SERVICE BULLETIN

No. 146B

SUBJECT: Elevator Butt Rib and Torque Tube Attachment Casting Cracks

MODELS AFFECTED: PA-23 Apaches - Serial Nos. 23-1 to 23-1284 incl., and 23-1286

ELE. BUTT RIB & ATTACHMENT CASTING	
SERVICE BULLETIN	146B
PIPER AIRCRAFT CORPORATION	
LOCK HAVEN, PENNSYLVANIA

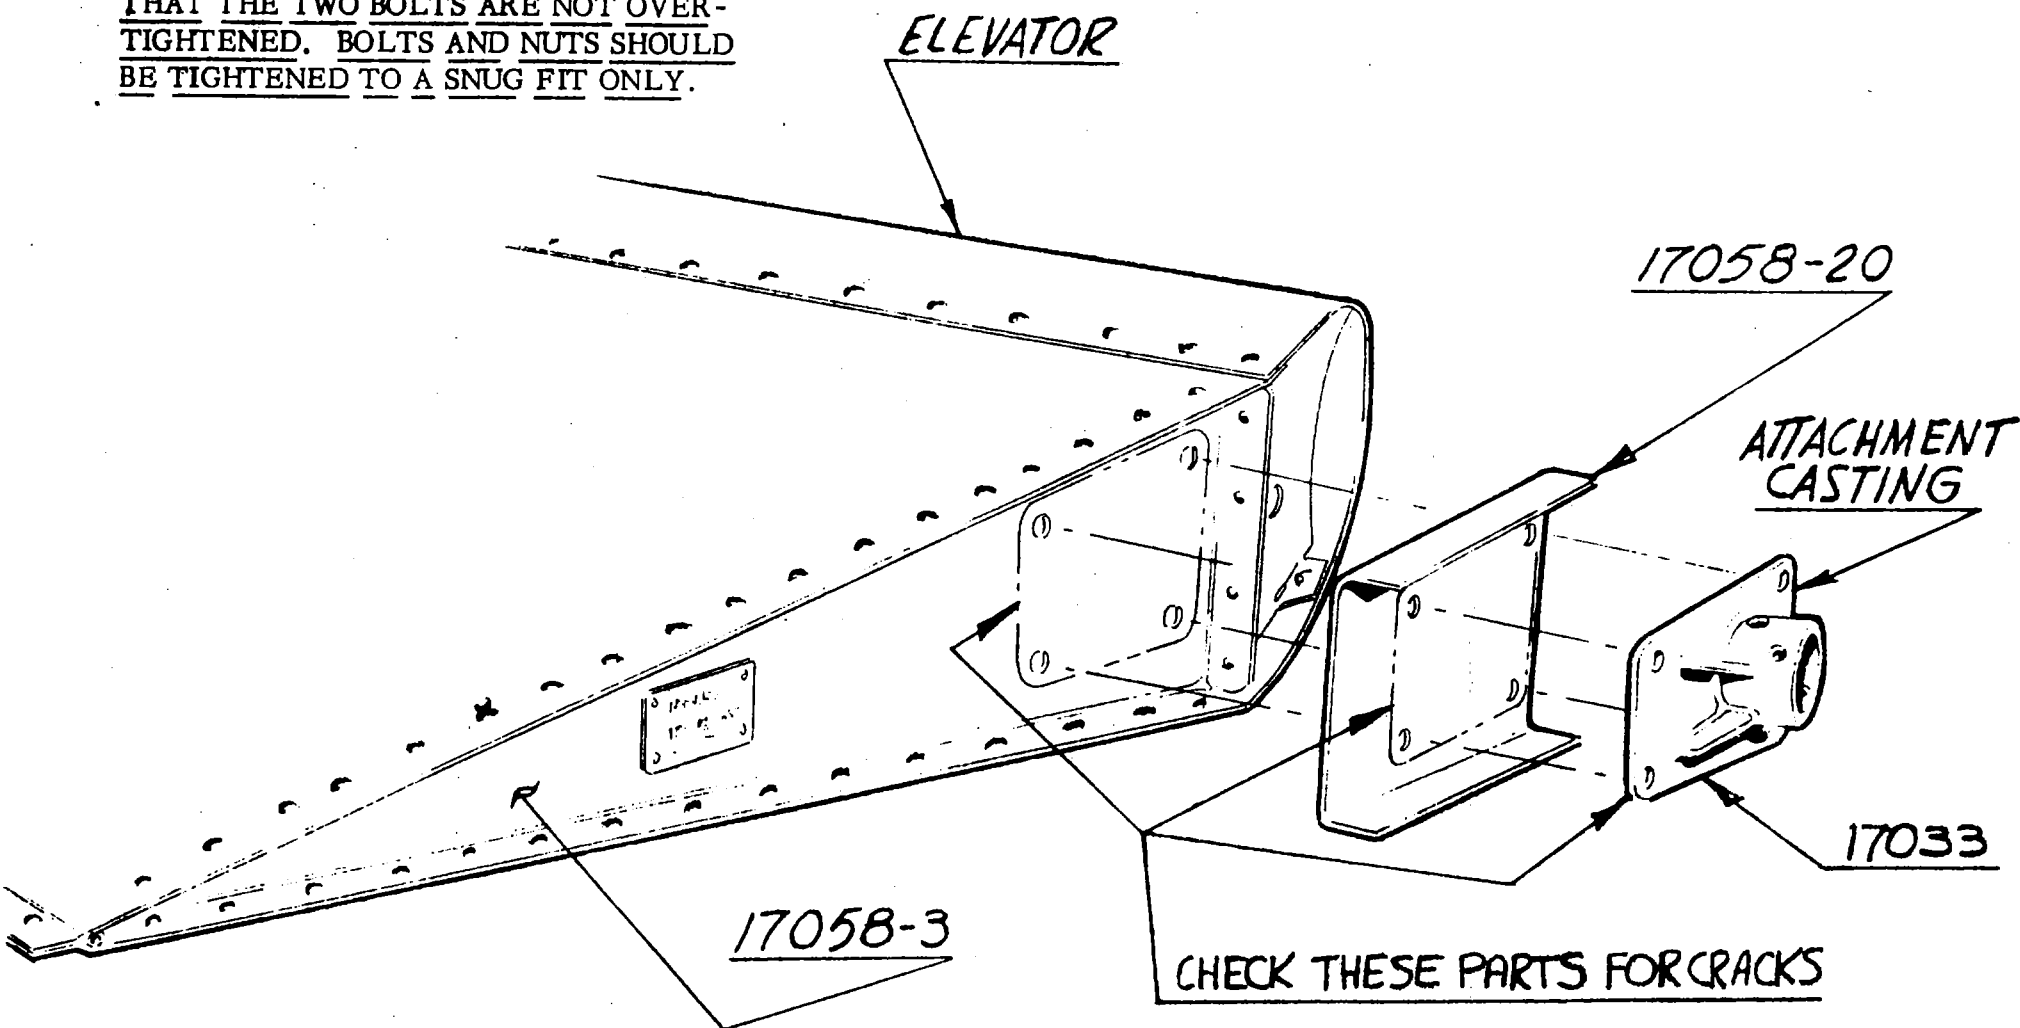
Investigation of field reports reveal that cracks have occurred in the butt rib and doubler plate of the PA-23 elevators. These cracks were caused by a slight misalignment between the elevator torque tube and the elevator assemblies. Also cracks have been found in the torque tube attachment casting, part number 17033-00, which were caused by over-tightening of the attachment bolts.

It is requested that the affected parts indicated on the accompanying sketch be inspected immediately and every 100 hours thereafter and if the rib, doubler plate or casting is cracked, it should be replaced with a new part. It will be necessary to remove the complete elevator torque tube assembly in order that the casting, part number 17033-00, can be taken off and inspected. After repairs have been made, it is important that the alignment of both elevator assemblies be accomplished in the following manner:

1. Assemble the elevator torque tube and both elevators into a single unit.
2. Hold complete assembly in attachment position and check alignment of the five hinge holes. All hinge pins should be a slip fit.
3. If the pins are not a slip fit, add shims under the torque tube attachment casting (shown on accompanying sketch) to obtain proper fit and alignment.
4. Install complete assembly to aircraft and safety.

NOTE
WHEN REINSTALLING ATTACHMENT
CASTING MAKE ABSOLUTELY CERTAIN
THAT THE TWO BOLTS ARE NOT OVER-
TIGHTENED. BOLTS AND NUTS SHOULD
BE TIGHTENED TO A SNUG FIT ONLY.
